SYDNEY NORTH PLANNING PANEL

Panel Reference	PPSSNH-140																											
DA Number	DA113/2020																											
LGA	Lane Cove																											
Proposed Development	Mixed-use development including a 143-bed residential care facility and commercial premises including a medical centre premises, and basement parking.																											
Street Address	4-18 Northwood Road & 274-274A Longueville Road, Lane Cove																											
Applicant/Owner	Applicant: City Plan (Contact: Elyse Kenny) Owner: Pathways Property Group Pty Ltd																											
Date of DA lodgement	28/08/2020																											
Number of Submissions	256																											
Recommendation	REFUSAL																											
Regional Development Criteria (Schedule 7 of the SEPP (State and Regional Development) 2011	Development that has a capital investment value of more than \$30 million (CIV \$40,837,440.00).																											
List of all relevant s4.15(1)(a) matters	<ul style="list-style-type: none">• List all of the relevant environmental planning instruments: s4.15(1)(a)(i)<ul style="list-style-type: none">- SEPP (Housing for Seniors or People

Figure 21. Sections – public domain 1 (Source: DA311 Rev DA1, Morrison Design Partnership Architects).

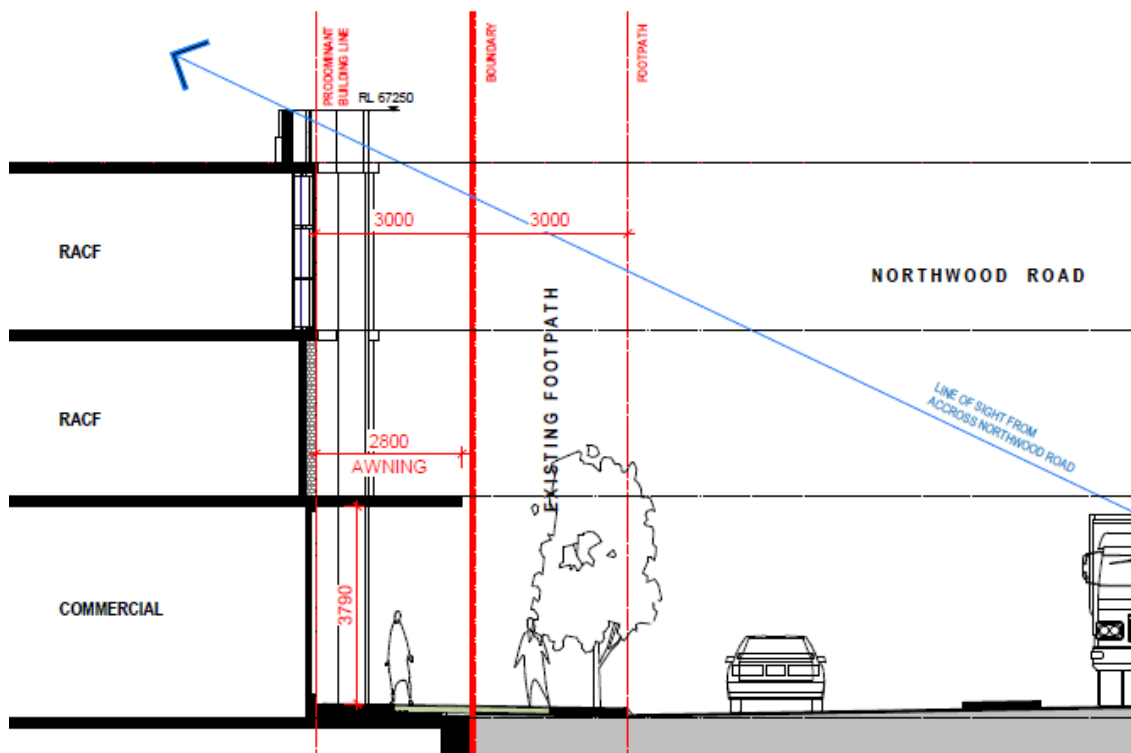
The proposal would not adhere to the *recessed third floor* requirement in that the proposed 3-storey form to the street alignment, as shown in the public domain section (**Figure 21**) and 3D pedestrian view (**Figures 22 & 23**) would create a walled effect at the pedestrian scale (**Figure 24**).

The 3-storey built form would not adhere to the desired future character for the neighbourhood expressed in the site-specific 2-storey to the street alignment and recessed upper level requirements under Clause 10. In this regard, the bulk and scale would establish an undesirable precedent for the centre. The proposed 3-storey form would not compromise the functional requirements of the aged care use. As stated previously, the proposal would not provide for an appropriate transition to adjacent low density residential uses to the south. For these reasons, the proposal does not satisfy objectives (1), (4), and (5).

Figure 25. Northern side boundary showing native Turpentine trees to be removed (Source: Landscape Plan LP01 prepared by Svalbe & Co)

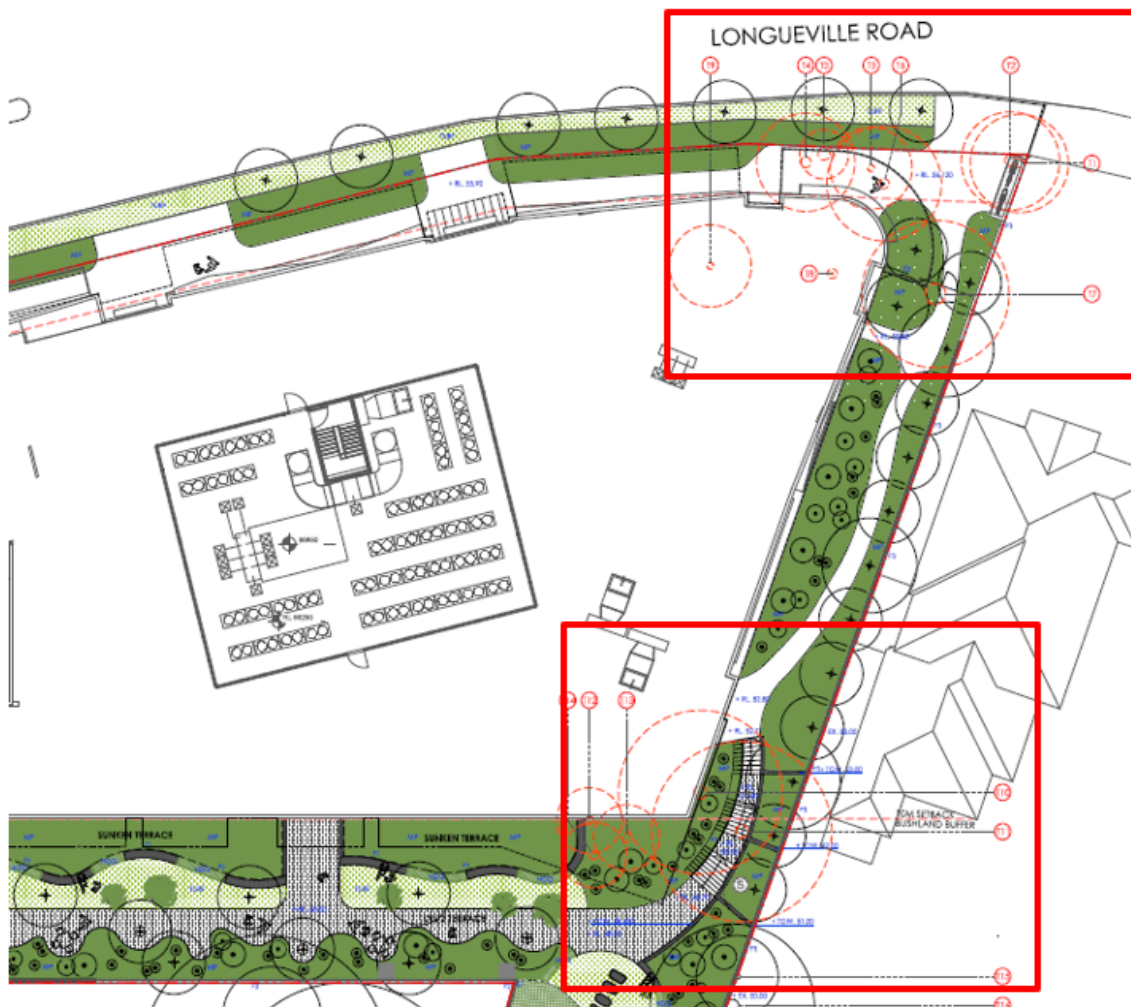
The removal of turpentine trees T1, T2, T5, T6, T10 and T11 is not supported (**Figures 25 & 26**). T10 and T11 along provide 300m² of canopy coverage (**Figure 27**). It is recommended that the proposal is amended to retain these native trees.

Figure 28. Non-compliant rear setback of 2.75m (southern side) and 3m (northern side) for the curtilage to the south-eastern section of the development.

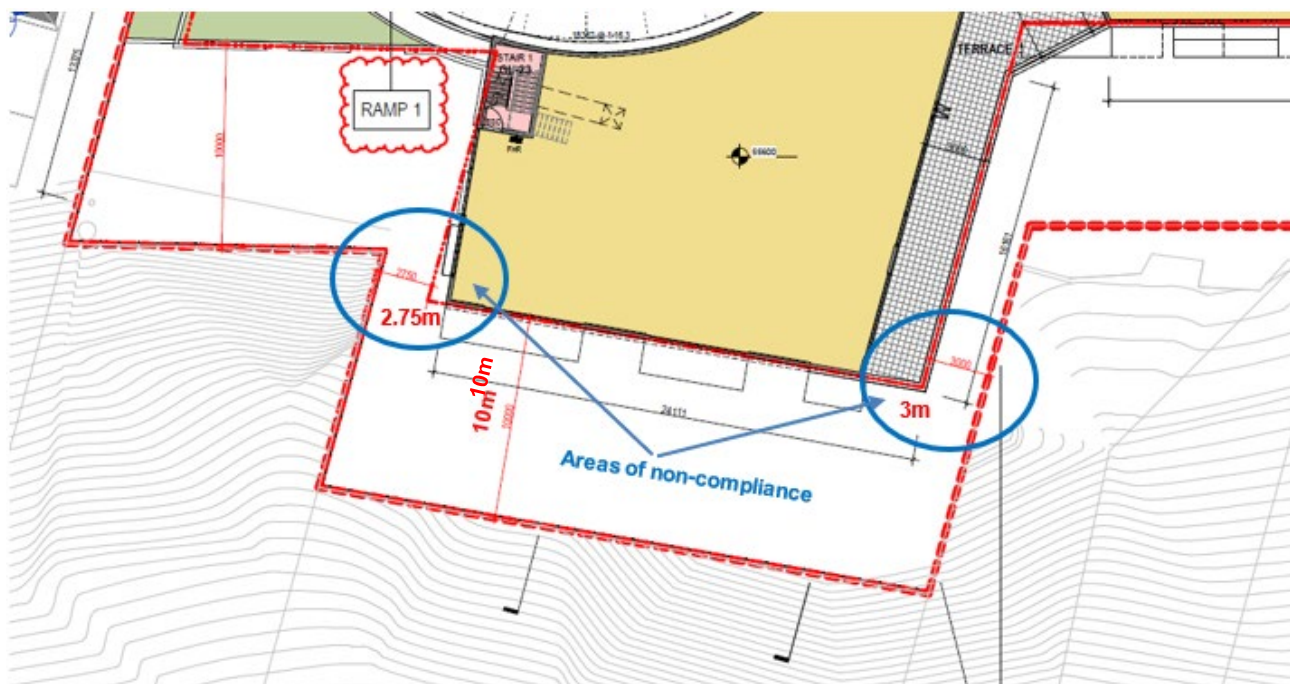
The curtilage to the proposed south-eastern section of the proposed building at the rear comprised of a 2.75m setback on the southern side and 3m setback on the northern side would not comply with the 10m buffer zone requirement, which seeks to ensure that the adjoining bushland is maintained and protected (Figure 28).

Figure 29. Indicative 10m buffer (Part H, Lane Cove DCP 2010)

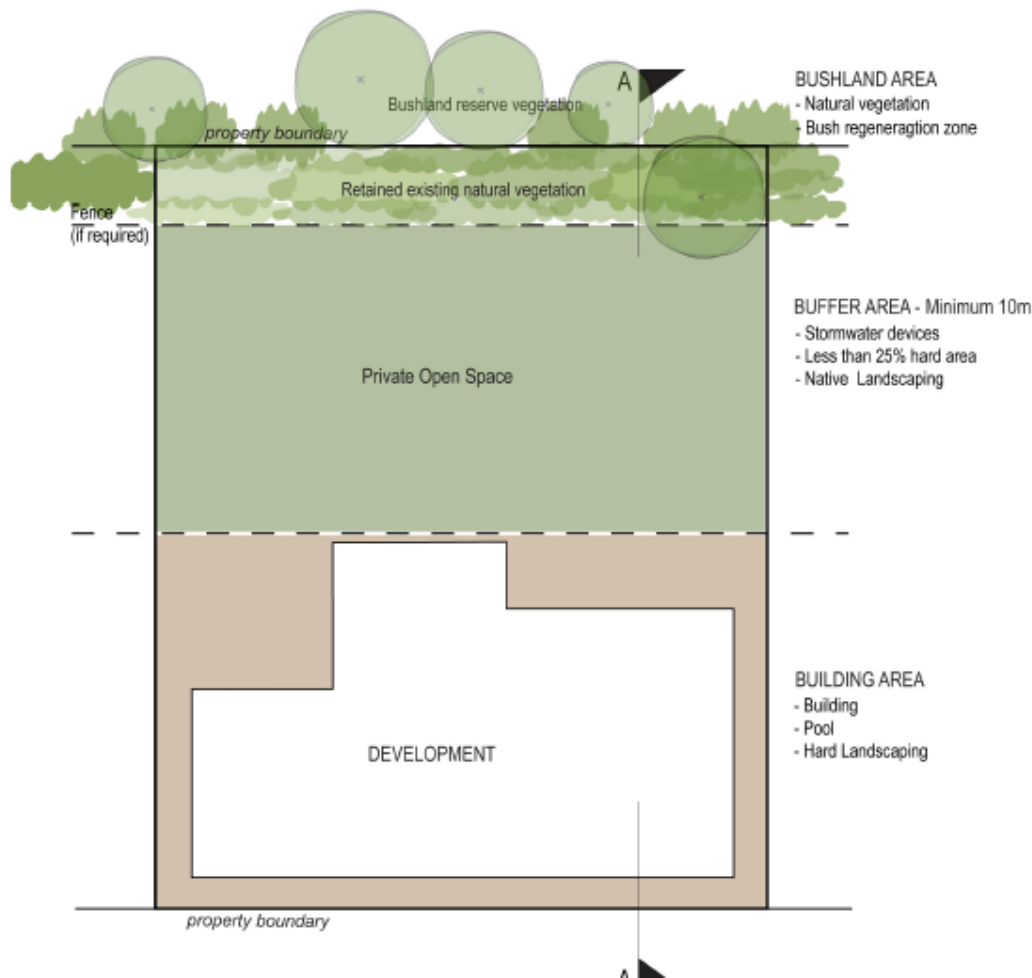
The proposal would not provide an appropriate transition between the building and bushland area so as to reduce the impacts of the development upon the bushland. This is contrary to Objective 1.

Provision (f) states that a minimum depth of 10m should be provided to adjoining bushland and should not impact upon any trees or vegetation (**Figure 29**). Except for the southern boundary, the curtilage to the south-eastern section of the development proposes a 2.75m and 3m setback to adjacent E2 zoned land. This is contrary to provision (f).
